MOTOR COACH
INDUSTRIES

SUBJECT: RECALL - TAG AXLE / DRIVESHAFT INTERFERENCE

Service Bulletin No. 277C

Service Bulletin No. 320

Figure 1.

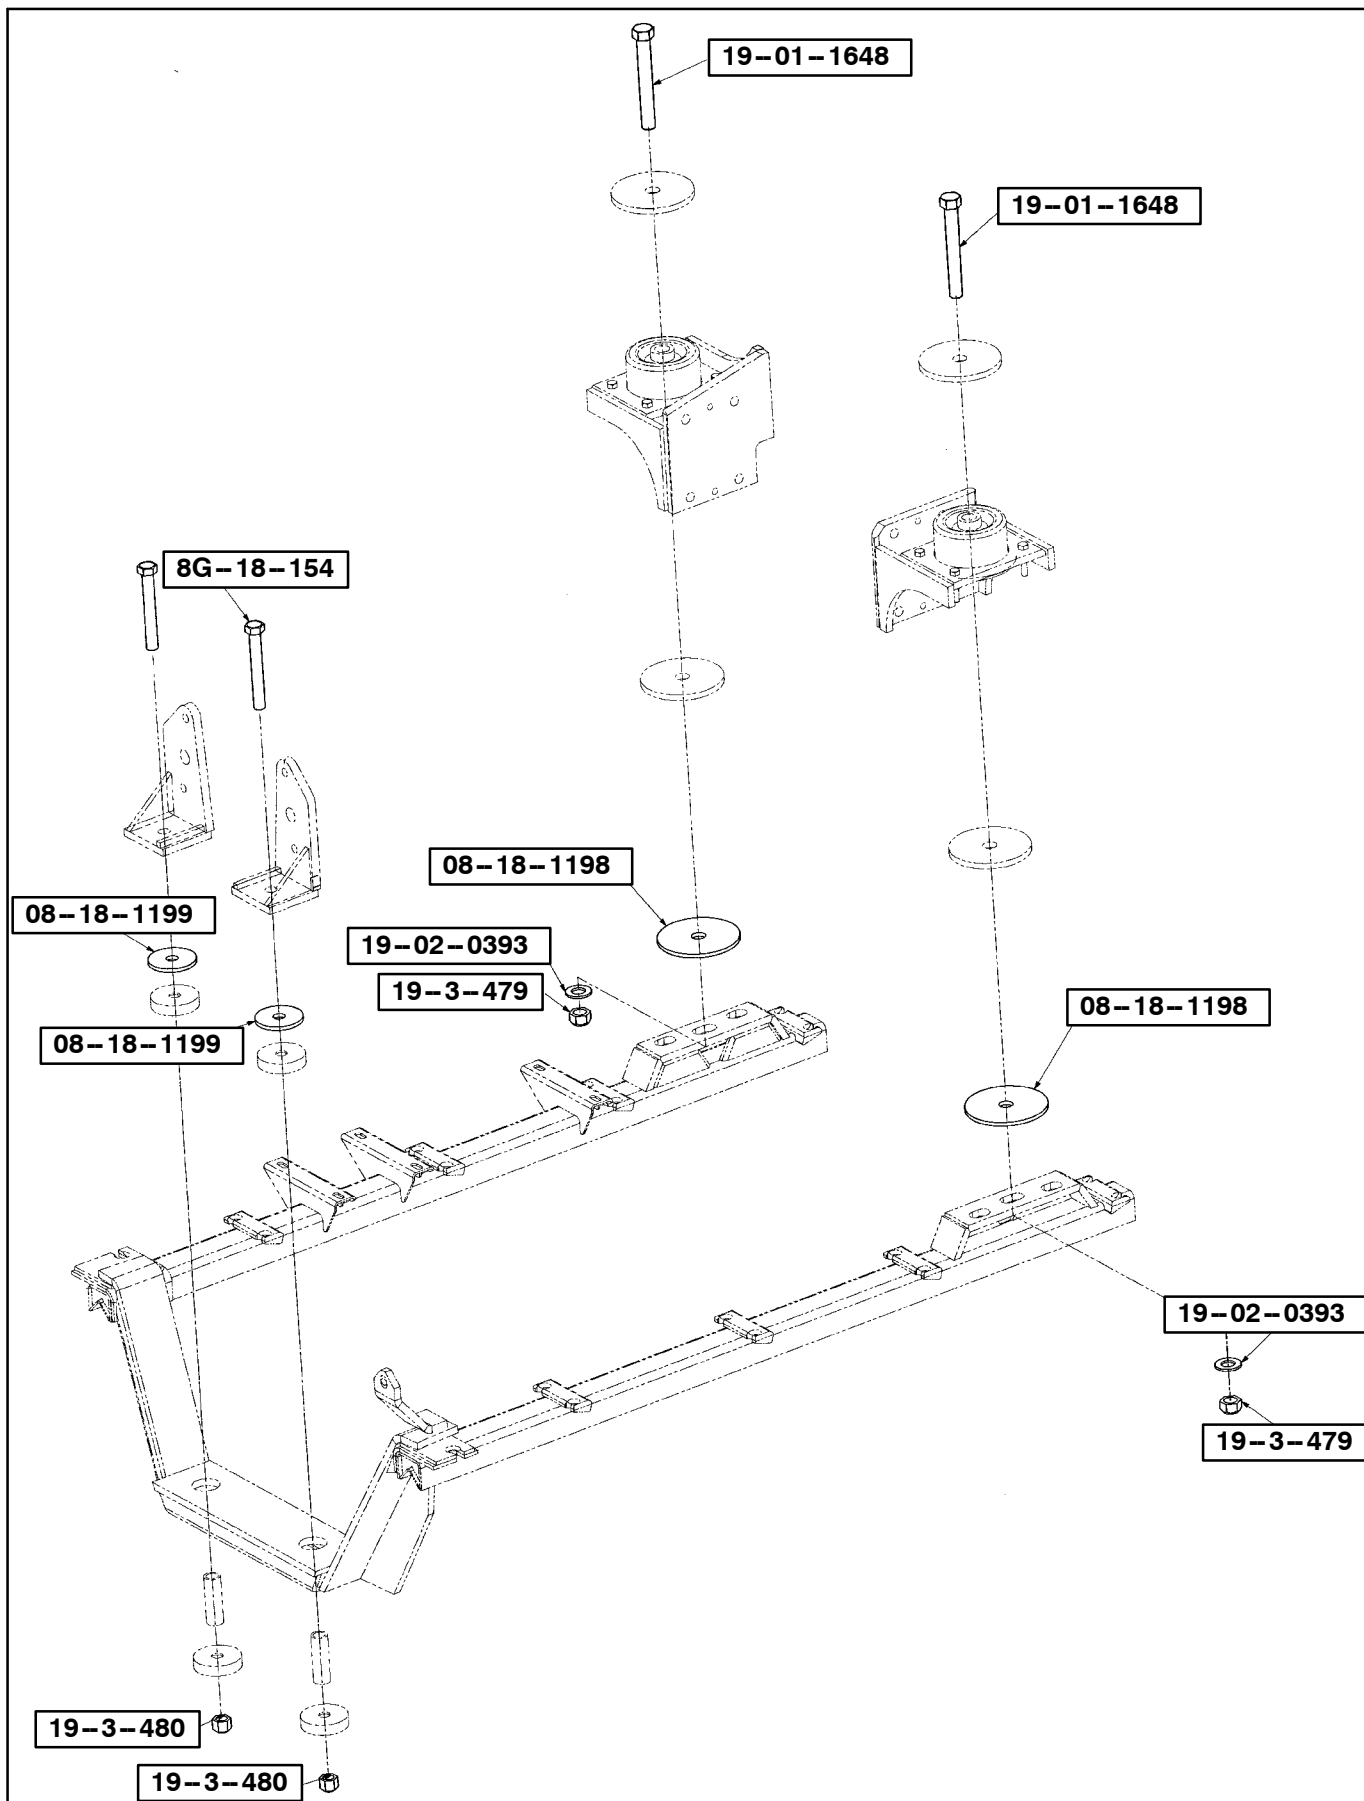
1. Turn the main battery disconnect switch to the “ OFF “ position. Chock both sides of the tires.
2. Open the engine compartment doors. Locate the engine remote and position the ENGINE RUN and ENGINE START to the OFF position.
3. Locate the engine cradle mounting hardware shown in Figure 1 (four locations).
4. Remove and discard the existing locknuts only from the four locations shown in Figure 1.

7. Remove and discard the existing fastener (and washer if applicable). Install appropriate shim (p/n 08-18-1198 or 08-18-1199) and new mounting hardware provided in Parts list. Tighten nut hand tight only.
8. Repeat Step 7. to next fastener.

9. Upon completion of installing the four shims and mounting hardware, lower the jack removing all stress from the engine. Remove the jack from under the coach.
10. Torque 19-3-480 to 285–385 lbs.-ft. Torque 19-3-479 to 451–546 lbs.-ft.

Figure 3. Reference photo.

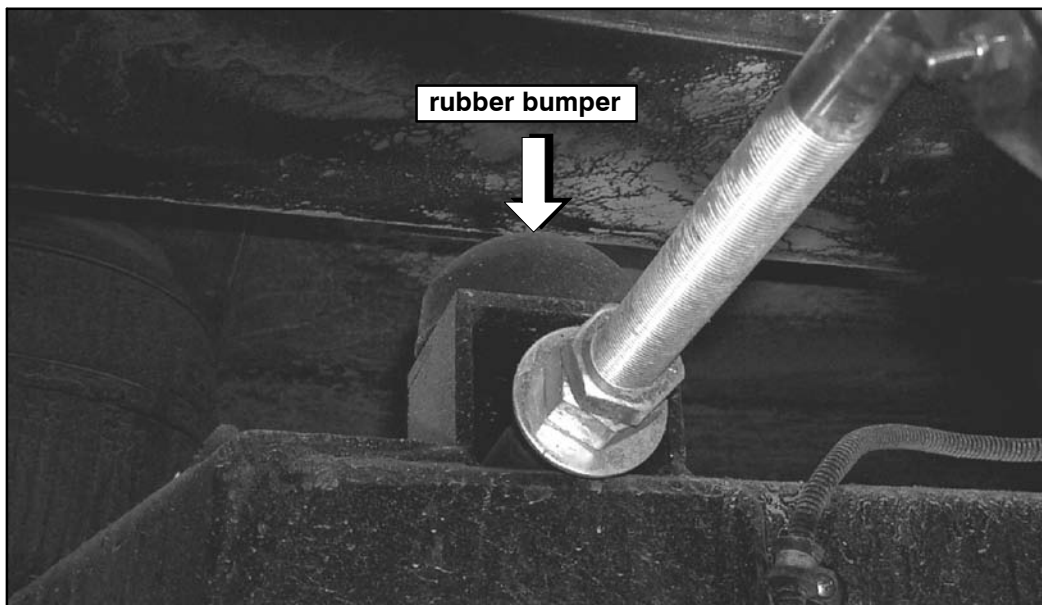
11. Locate the four existing rubber bumpers on the tag axle suspension assembly (Figures 3 and 5).

13. Disk sand the mounting surface in preparation of good reassembly.
14. Install the new rubber bumper (p/n 12G-1-5) and bumper block spacer (p/n 12R-1-6) (Detail B / Figure 5).

Figure 4. Reference photo.

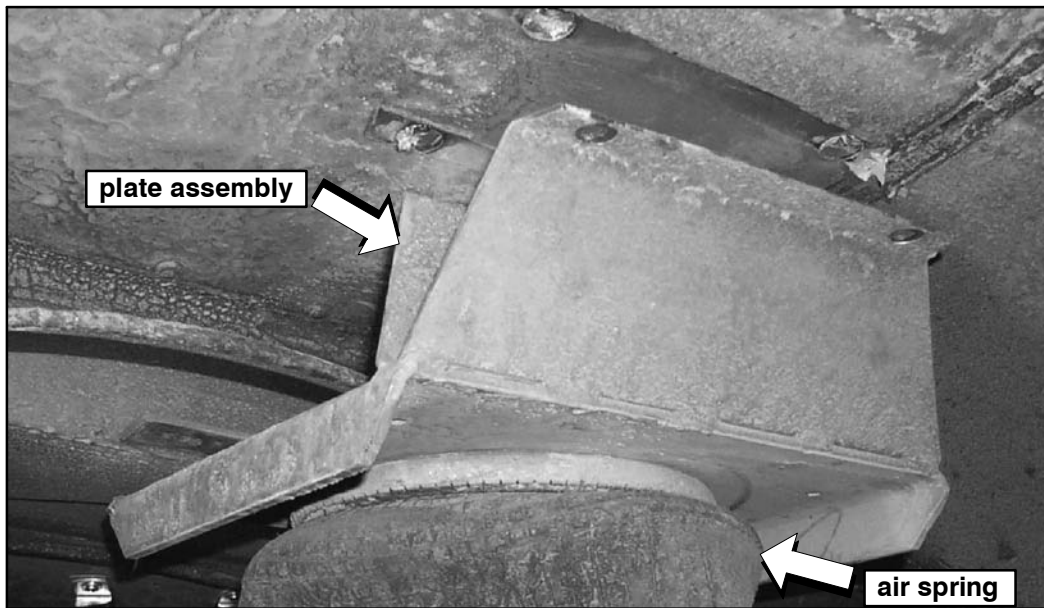
15. Remove and discard the plate assembly and mounting hardware (Figures 4 and 5).

16. Install the new plate assembly (p/n 12-04-1160) and spacer (p/n 12-04-1083) in the locations shown in Figure 5., using the new plate assembly mounting hardware provided in the Parts list. Torque nut (p/n 19-3-314) to 18–22 ft.-lbs.
17. Align and position the spacer (p/n 12-04-1074) in the location shown in Figure 5.

Figure 2.

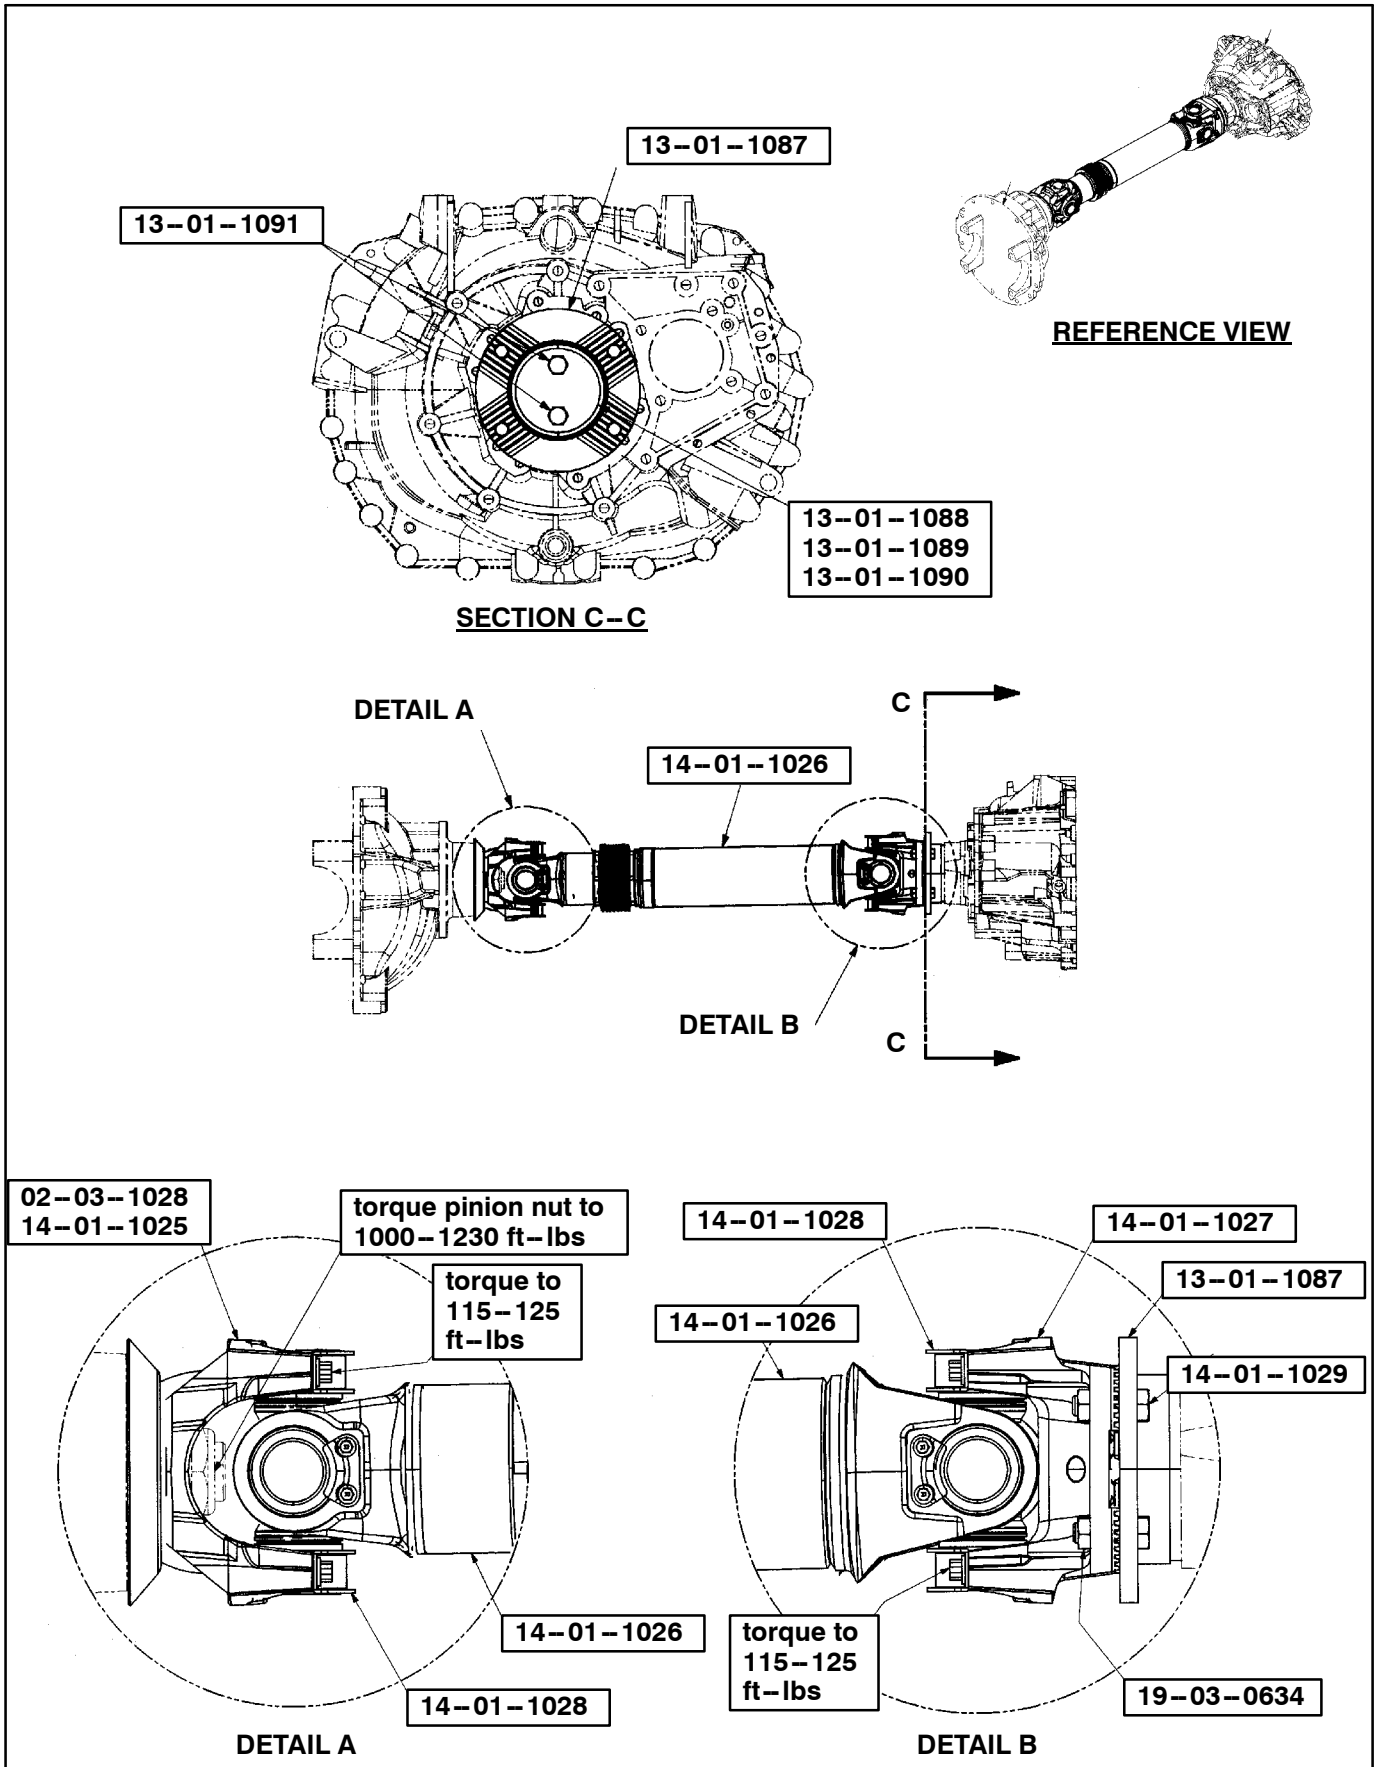
11. Using tool no. 20-710, install the drive axle pinion seal (p/n 02-03-1028) (refer to Figure 2).
12. Lubricate the seal mounting surface of the end yoke assembly (p/n 14-01-1025) and install on the output shaft taking care not to damage the seal. Install the washer and pinion nut removed in Step 10. and torque the pinion nut to 1000-1230 lb-ft.

16. Using the straps and bolts kit (p/n 14-01-1028) , install the driveshaft (p/n 14-01-1026) being sure to install the slip yoke end towards the drive axle. Torque the bearing cap bolts to 115 - 125 lb-ft.
17. Re-fill the drive axle with oil saved in Step 2. Top-up level as required.
18. Re-fill the transmission with fluid saved in Step 2. Top-up level as required.
19. Using grease (p/n 21-7512-5) , grease driveshaft u-joint.
20. Reinstall the driveshaft guard and fasteners removed in Step 2. Torque fasteners to 16-28 lb-ft.

Figure 5. ZF transmission serial number plate.

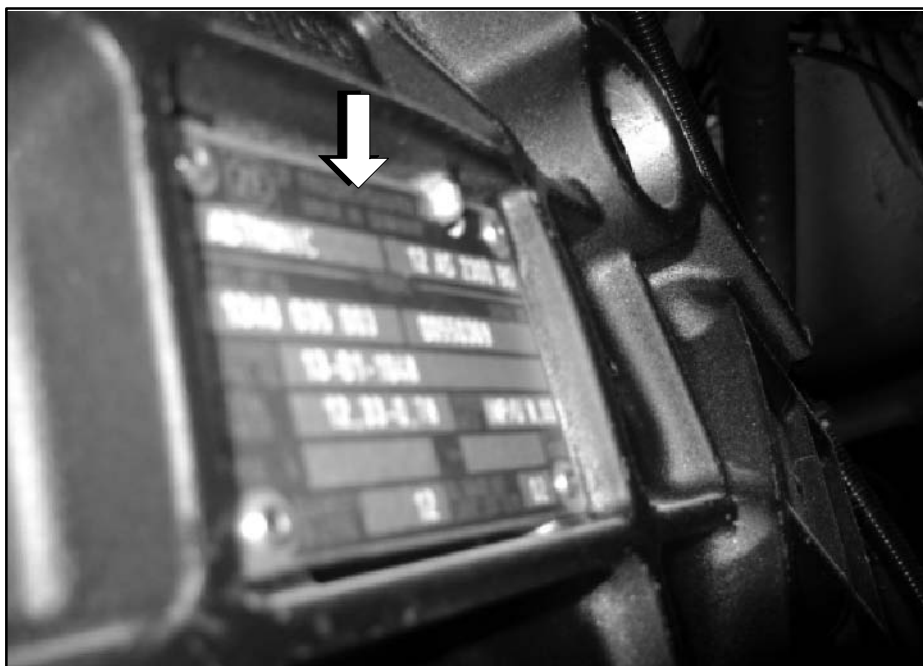
24. Carefully align and apply the applicable decal, p/n 13-01-1096 **or** 13-01-1097 over the existing transmission serial number plate (refer to Figure 5). Discard other decal.

Decal, p/n 13-01-1096, is applicable for unit numbers 58311–58583 (refer to Figure 3).

Decal, p/n 13-01-1097, is applicable for unit numbers 56555–57549 (refer to Figure 4).
